Architectural Excellence & Design Review Panel

Meeting Minutes & Recommendations

Site Address:	62 Constitution Road Dulwich Hill
Proposal:	A 7 storey mixed use proposal with 14 apartments proposed above ground floor commercial tenancies.
Application No.:	DA/2021/0571
Meeting Date:	7 September 2021
Previous Meeting Date:	None
Panel Members:	Peter Ireland – chair; Jocelyn Jackson; and Jon Johannsen
Apologies:	-
Council staff:	Vishal Lakhia, Niall Macken, and Asher Richardson.
Guests:	-
Declarations of Interest:	None
Applicant or applicant's representatives to address the panel:	The applicant was invited but did not attend the AEDRP meeting.

Sketched suggestion for clarity.

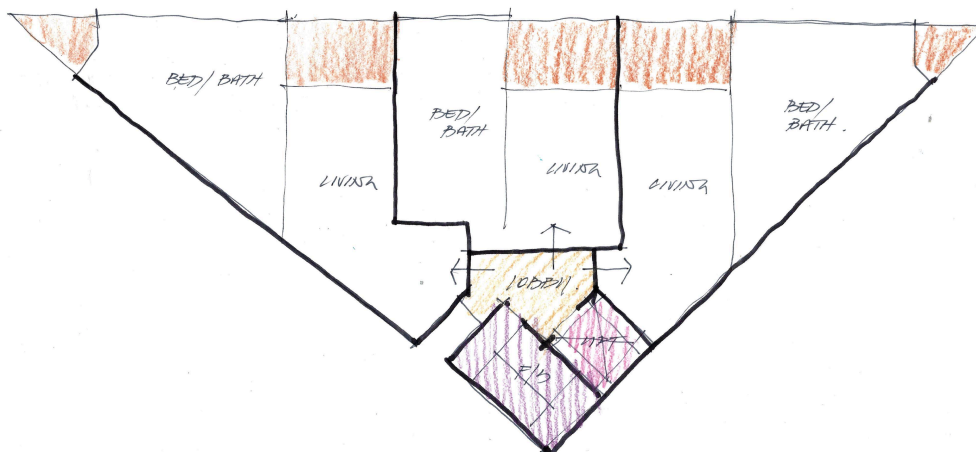
1. The Panel considers that the typical residential levels require further refinement in terms of spatial planning of the apartments. The entry foyers, living, dining and kitchen areas in a majority of apartments (E.g. apartments G01, 102, 103 on a typical level) seem constrained and it appears not possible to furnish these spaces and maintain adequate circulation or amenity.
2. The Panel suggested a strategy to address the density and residential amenity concern would be to re-distribute floor area from the 3 constrained apartments to 2 generously planned apartments per floor. Or to reconsider the arrangement of living and bedroom spaces as indicated in the attached sketch provided for clarity.
